CITY OF PORTLAND BUILDING PERMIT

Job ID: 2011-07-1652-ALTR

Permit - 2011-07-1652
amendment - 2011-12859

RE: 93 Westland Avenue Renovation project

Bathroom Detail Scale 1/2" = 1'-0"

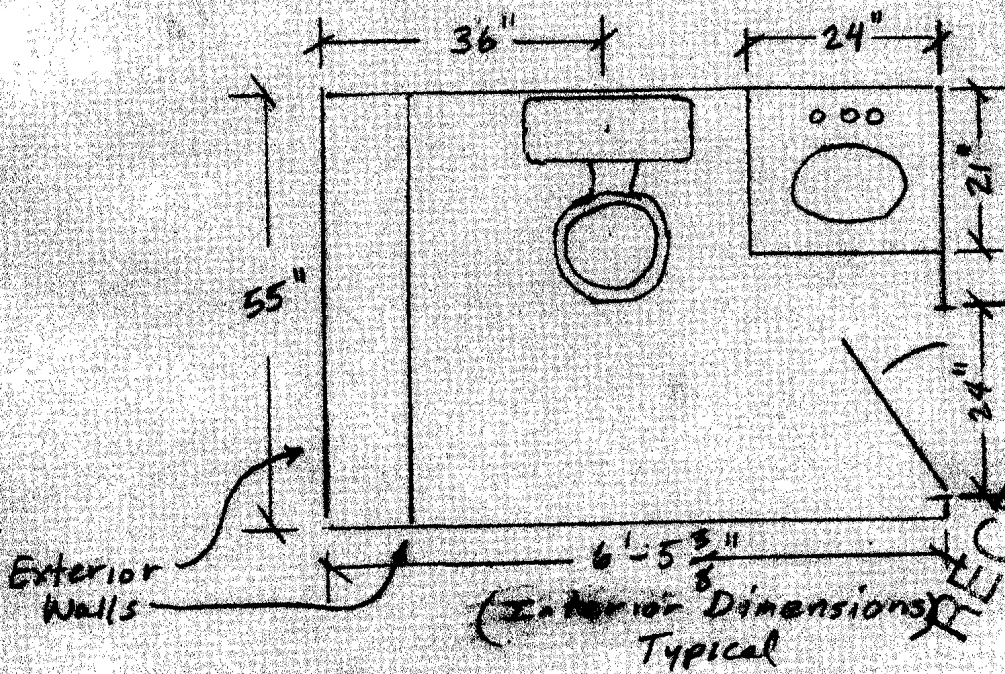
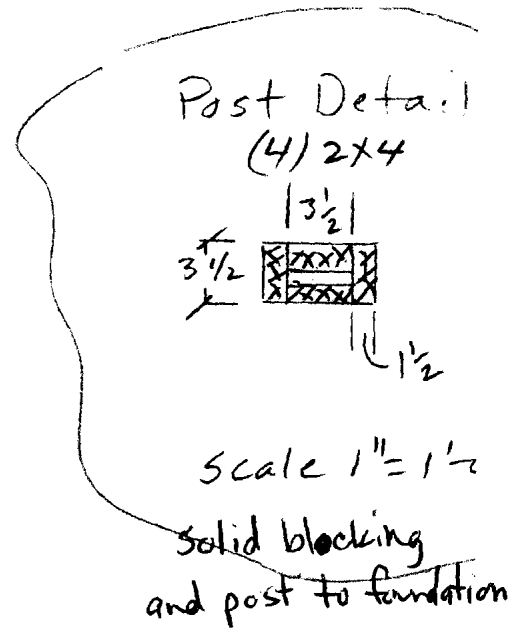
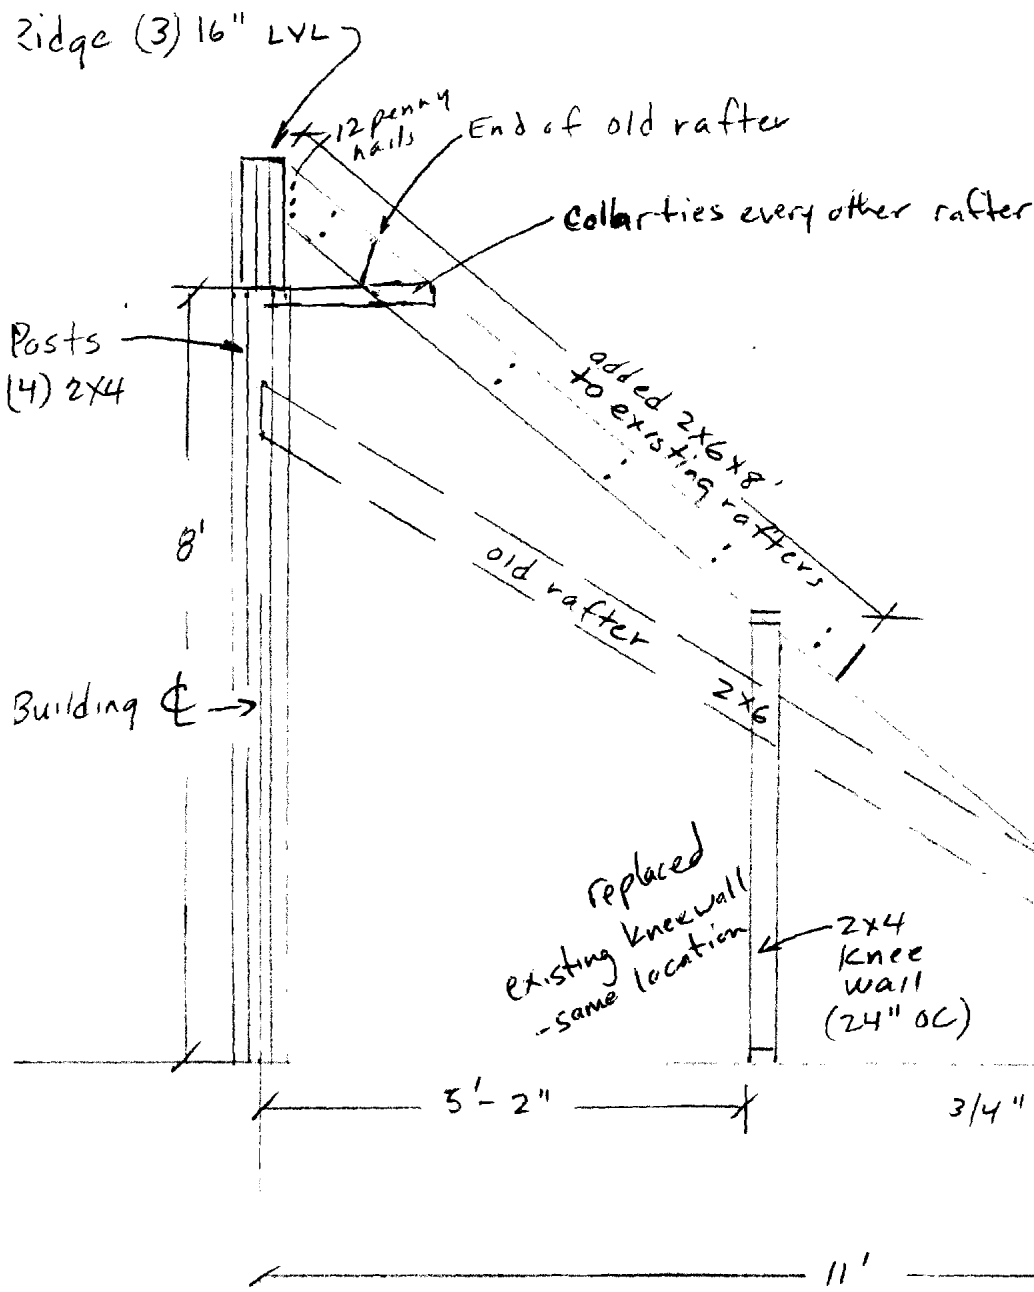
* Will install ventilation fan or small window in bath for ventilation.

1. Application approval based upon information provided by applicant, including updated plans from the structural engineer. Any deviation from approved plans requires separate review and approval prior to work.
2. Separate permits are required for any electrical, plumbing, sprinkler, fire alarm, HVAC systems, heating appliances, including pellet/wood stoves, commercial hood exhaust systems and fuel tanks. Separate plans may need to be submitted for approval as a part of this process.
3. The 2nd floor half-bath is not approved due to noncompliance with 6'8" headroom requirements.
4. All previous approvals and inspections apply.

SK-1
1 OF 5

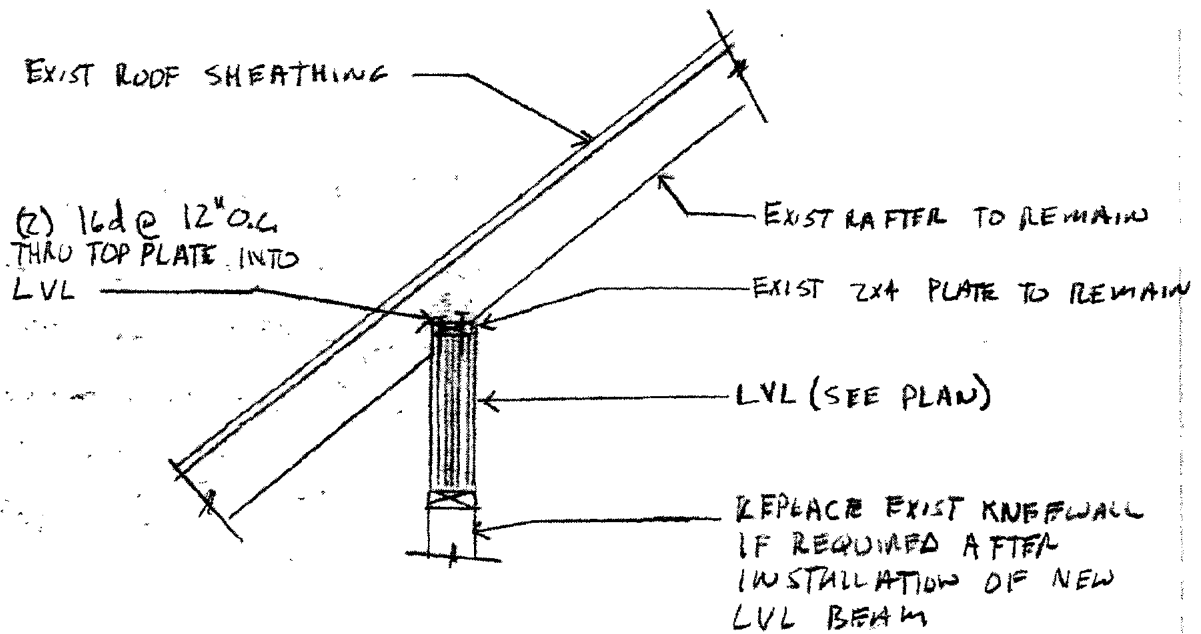
The first item I reviewed was a ridge beam running from the southwest side of the house (labeled Ridge Beam 3 on Sketch SK-1). The ridge beam is a 1 3/4" x 11 7/8" LVL, and spans approximately 23'-0". This existing ridge beam was found to be overstressed according to current building code requirements. It is recommended that the contractor install a vertical support to reduce the span of the ridge beam to meet current building code requirements. The installation of this support is detailed on the attached sketches.

SK-2
2 OF 5

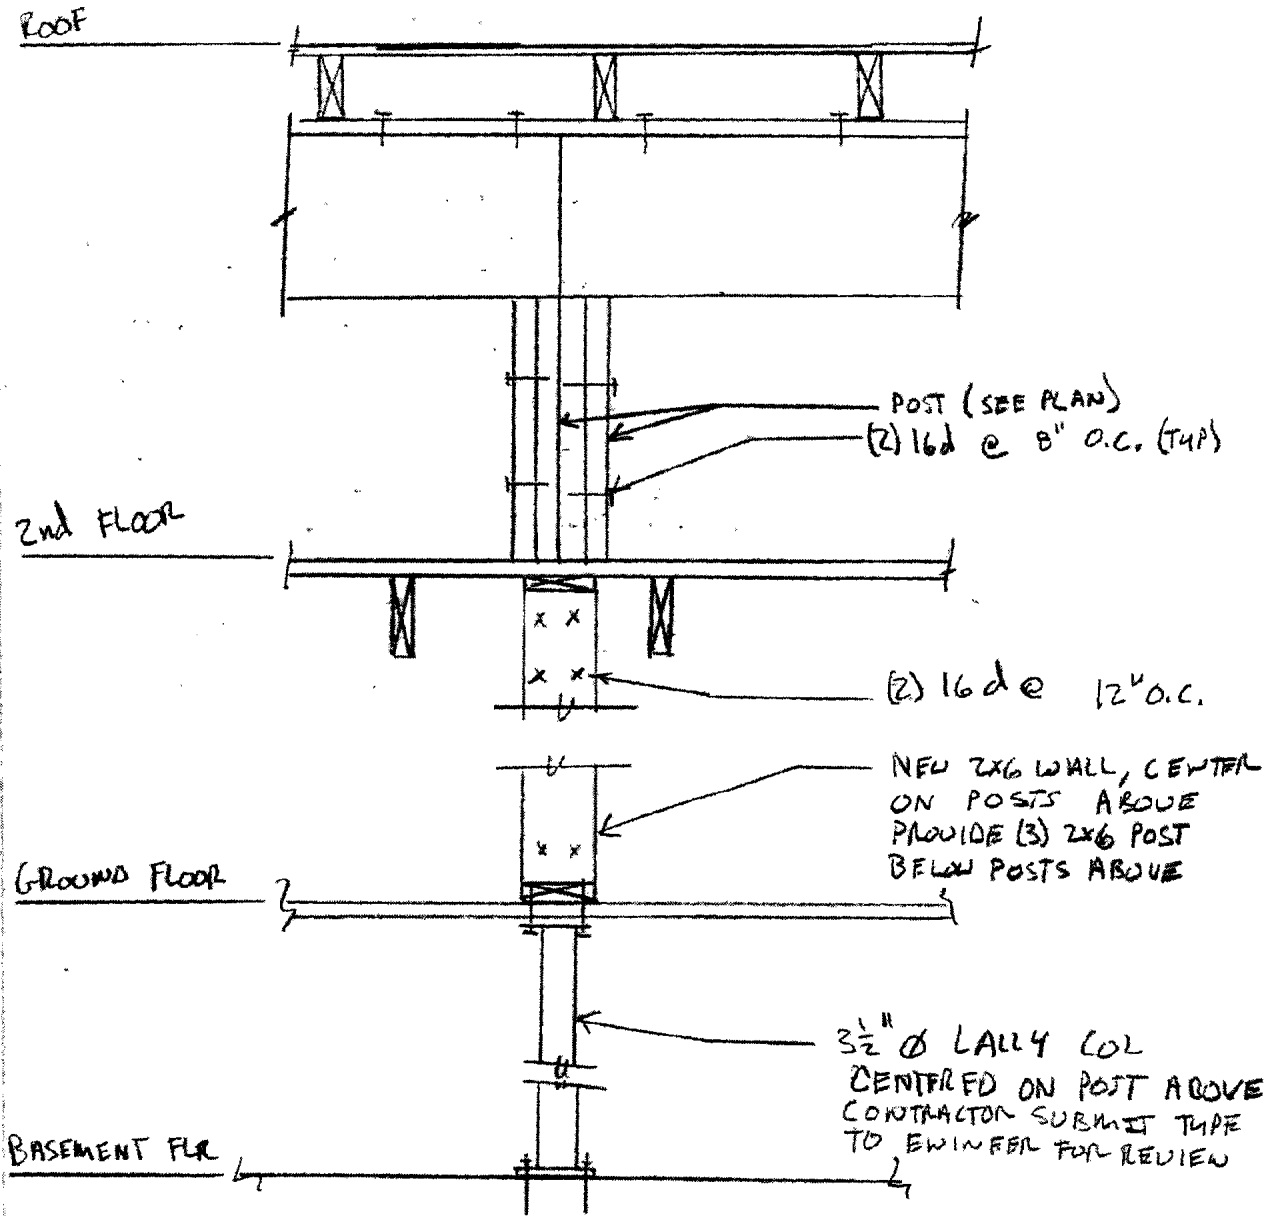
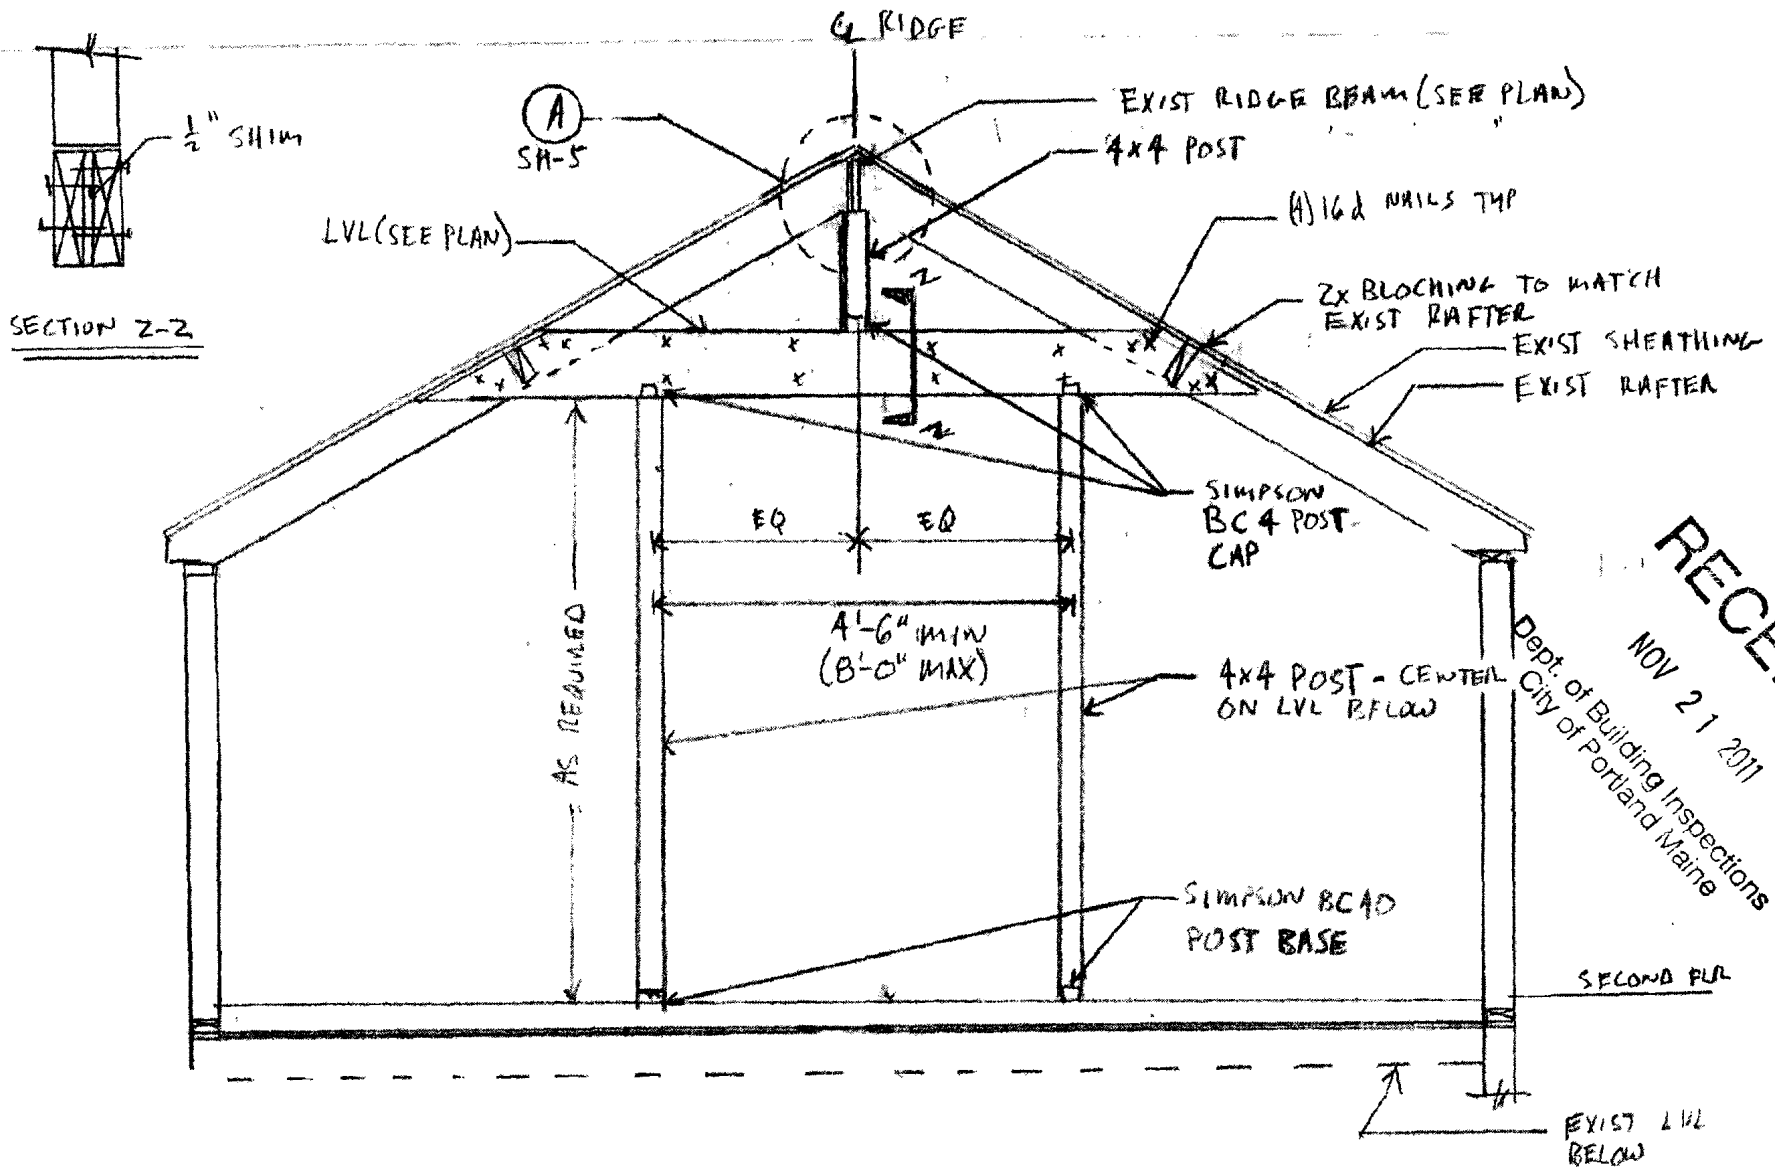
The second issue I reviewed was the roof rafters on the North side of the building. The original roof was reportedly lifted at the ridgeline to allow for more living space on the second floor. The rafters currently bear on the exterior wall at one end, a new knee wall at center span, and a new ridge beam at the other end. The new knee wall at center span is supported by the second floor framing. New rafters were sistered alongside the existing rafters to span from the knee wall to the center ridgeline. Upon review of this framing for code compliance, I found that the floor below the knee wall lacked the structural capacity to carry the roof loads from above. I recommend removing the existing knee wall and installing two LVL beams to remove the roof load from the existing floor framing. Details of this recommended repair are shown on the attached sketches.

PARTIAL FIRST FLOOR FRAMING
 NTS
 THOMPSON RESIDENCE

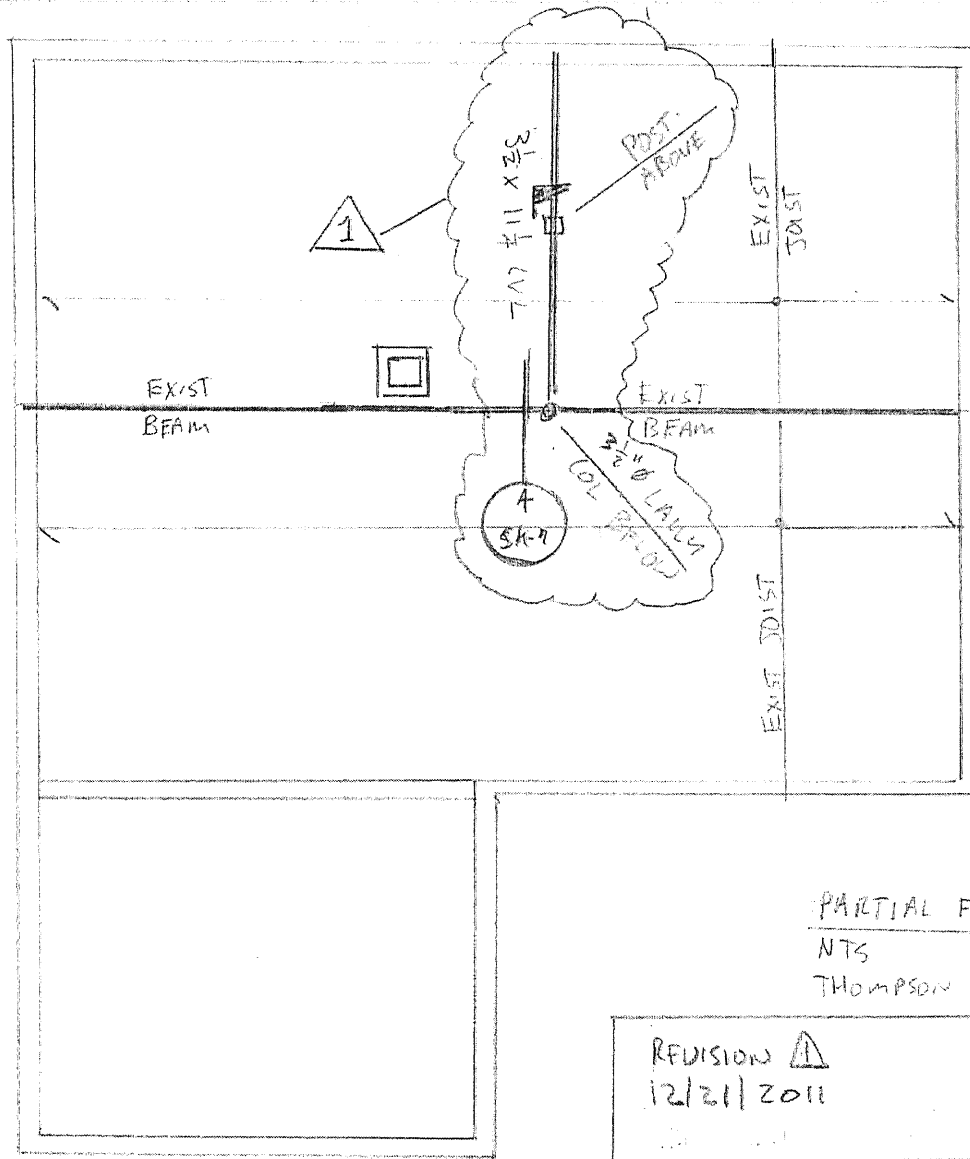
Please find an engineer's drawing describing the posting of the LVL in the upstairs that was added to support the building's original roof at the kneewall. This modified drawing now includes an additional LVL and Simpson hanger in the basement that we decided to add so that the lolly column posting could be moved to the center-line of the building.
